RESPONSE TO BRISBANE CITY COUNCIL FURTHER ADVICE LETTER

CHANGE APPLICATION (MINOR CHANGE) PURSUANT TO SECTION 81 OF *PLANNING ACT 2016*), OVER LAND LOCATED AT 27 LORNE STREET AND 26-32 SAMFORD ROAD, ALDERLEY

COUNCIL REFERENCE: A007053603

Further Advice Response

Figure 1: Relocated bicycle spaces (outlined in blue) (Source: Loucas Zahos Architects, 2026)

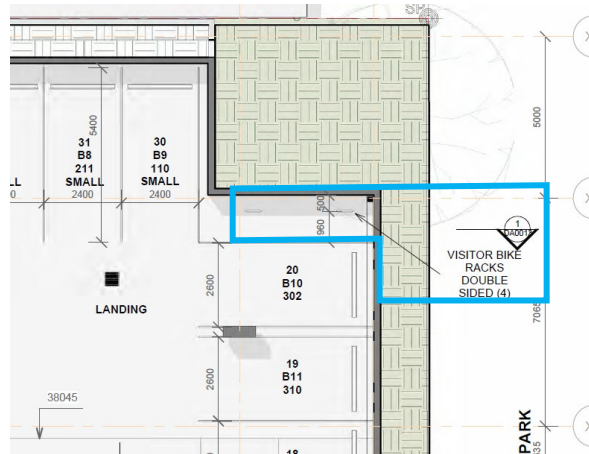
- a) *The wall mounted visitor bike rack adjacent the proposed "01 B24 visitor" parking is inaccessible.*
- b) *The proposed shared bay area of the relocated PWD space is impacted by a structural column.*
- c) *Minimum 2.5m height clearance at the relocated PWD/shared bay is not demonstrated/confirmed.*
- d) *The proposed visitor PWD within the basement appears have a further travel distance to building entry than the current outcome on ground level.*

With respect to **Item 1(a)** the wall mounted visitor bike rack, previously adjacent to the proposed "01 B24 visitor" parking space has been relocated to be adjacent to the car park identified as "B10", refer to **Figure 1**. The revised bicycle parking is provided within an accessible location.

Figure 2: Revised Driveway Ramp / Bin Room – Ground Level (outlined in blue) (Source: Loucas Zahos Architects, 2026)

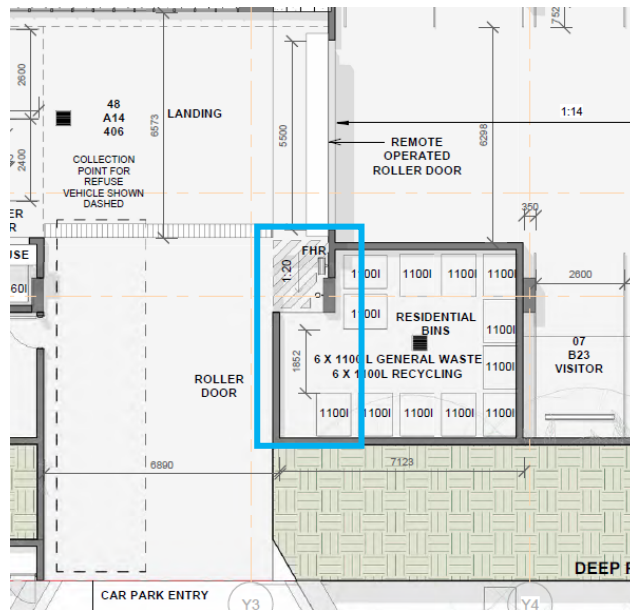
A review of the 'General Arrangement Plan Ground Floor' has not demonstrated the RL's of the driveway and Residential Bin room FFL. It is unclear if the transfer of bins from the bin room to the rear of the RCV is free of steps and other obstructions. Demonstrate the following:

- b) *Clearly demonstrate the RL's of the driveway ramp and bin room.*
- c) *Furthermore, demonstrate the bin transfer path does not exceed a gradient of 1:20 and is free of steps.*

In response to Item 3, the General Arrangement Ground Floor Plan (refuse room and transfer path) has been reconfigured and revised to clearly demonstrate the RL's of the driveway ramp and bin room and that the bin transfer path does not exceed a 1:20 gradient and is free of steps. Please refer to **Figure 2** below.

As detailed within the RPEQ Refuse Engineering Letter, prepared by AJEM Sustainable Waste and Recourse Consulting (**Attachment D**), the proposed amendment to the bin transfer route is suitable and provides sufficient clearance of the transferring of refuse bins.
